Access Compliance Report Public Rights-of-Way (Pedestrian Signals)

Main Street: **CHIQUITA_CANYON_DR** Cross Street: **N/A** Location: **SE**

ADA ID: **SGRK211124133607** Signal Type: **One Push Button-Non APS** Overall Compliance: **No** Severity Scores: **BTN 1: 35** **BTN 2: N/A** **No BTN: N/A**

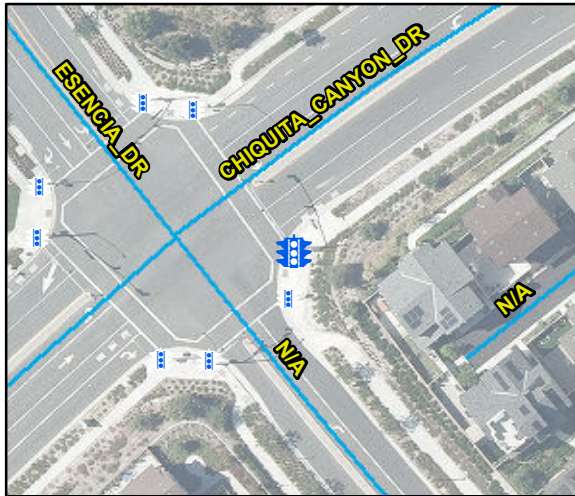
Possible Solutions: Replace Signal Push Button With APS Button. Remove and Replace Clear Space.

OC Std/PROW: **R404.2, R404.3, MUTCD 4e.08**
